RAB Focus Group QU-3 Meeting

The Restoration Advisory Board (RAB) focus group met on Monday, 20, 2003 to discuss the "Revised Draft Feasibility Study Report" for Operable Unit -3. The meeting was held at Bert Morgan's home at 6 pm. The RAB members in attendance were Bert Morgan, Lea Loizos, Dale Smith, Bill Smith, Kevin Reilly and George Humphreys. In addition, Professor Kent Udell from U. C. Berkeley had reviewed the report and was in attendance. Later, the Navy's Remedial Project Manager, Rick Weissenborn, arrived and joined the discussion.

Subject: Comments on "revised Draft Feasibility Study Report, Operable Unit-3. Site 1- 1943-1956 Disposal Area, Dec. 12, 2002, D. S. A 029.10145. Contract No. N68711-00-D-005, Delivery Order 29"

FIGURE - 1

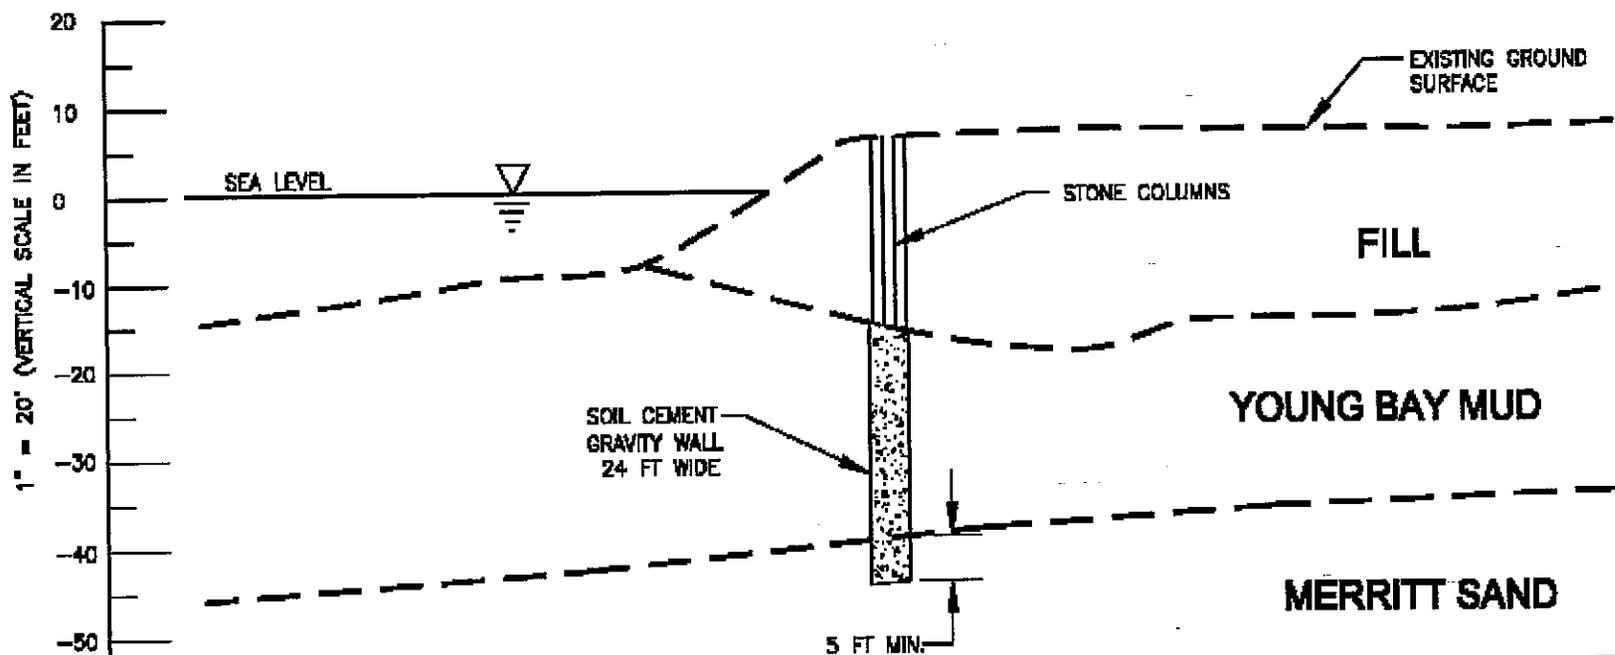
Professor Udell pointed that what is being proposed by the Navy is not a permanent solution. Long-term performance of the iron bed in the "funnel and gate" treatment system has not been demonstrated. Periodic replacement of the iron filings would be required. This means the City periodically would have to dig up a portion of the golf course to replace the iron filings. The replacement interval would be 7 years or more. Continued aeration of the biosparger for the removal of benzene, toluene, and dechlorinated solvents also would be necessary.

Professor Udell thought that the results of the hydraulic computer modelling were questionable. He asked whether flow through the bottom of the landfill had been taken into consideration. Rick Weissenborn said that it had not. Also, Professor Udell noted that one would expect flow through the cap to be inversely proportional to thickness. The model showed that increasing the cap from 24-in. to 48-in. only reduced the water inflow by 50,000 gal/yr out of a 11,753,000 gal/yr total. Bill Smith asked whether the "young bay mud" was a continuous, uninterrupted layer separating the waste cells from the underlying Merritt Sand water-bearing zone.

Another question is whether forced air injection in the biosparger zone, coupled with the back and forth tidal flow, would cause oxidation of the iron filings in the funnel and gate system?
